TECHNICAL SERVICE BULLETIN

SUBJECT:		REAR CONTROL ARM SQUEAK		No:	TSB-05-34-001
				DATE:	July, 2005
				MODEL:	See below
CIRCULATE TO:	<input type="checkbox"/> GENERAL MANAGER	<input checked="" type="checkbox"/> PARTS MANAGER	<input checked="" type="checkbox"/> TECHNICIAN		
<input checked="" type="checkbox"/> SERVICE ADVISOR	<input checked="" type="checkbox"/> SERVICE MANAGER	<input checked="" type="checkbox"/> WARRANTY PROCESSOR	<input type="checkbox"/> SALES MANAGER

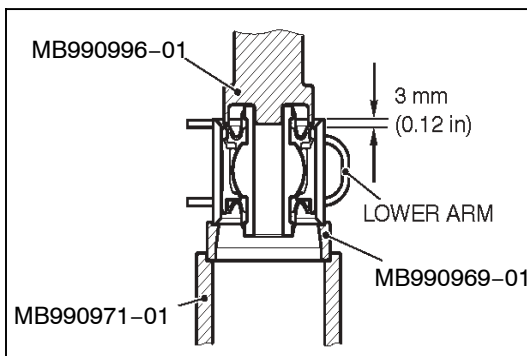
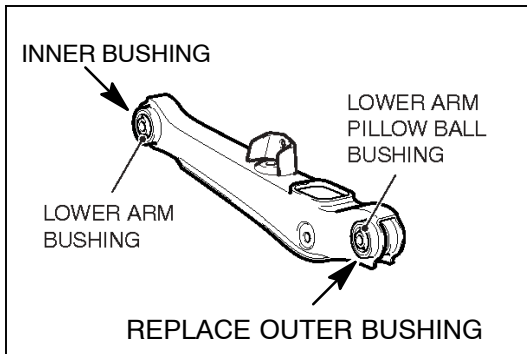
This bulletin addresses customer complaints of a squeaking noise coming from the rear of the vehicle while driving. Water intrusion through the control arm bushing seal may allow corrosion, resulting in a squeak during control arm movement. The new replacement parts listed in this bulletin have improved bushing seals to prevent water intrusion.

1. Test drive the vehicle. Use Chassis Ears® to determine if the noise is coming from the upper or lower control arm (or both).
 - a. If the noise is NOT coming from a rear control arm, diagnose and repair/replace the appropriate component(s), as necessary. Do not continue with this bulletin procedure.
 - b. If the noise is coming from a rear control arm, continue with this bulletin procedure.
2. On the side of the vehicle where the noise occurs, determine whether the noise occurs at the upper or the lower control arm. Use the new parts listed in the PARTS INFORMATION section of this bulletin. Refer to Group 34 in the appropriate service manual.

- If the noise occurs at the lower control arm, replace the **lower control arm outer (pillow ball) bushing.**
- If the noise occurs at the upper control arm, replace the **upper control arm assembly.**

Use special tools MB990969-01, MB990971-01, and MB990996-01 to drive out and press-fit the bushing. After press-fitting, the space between the edges of the bushing outer sleeve and the lower arm should be 3 mm (0.12 inch).
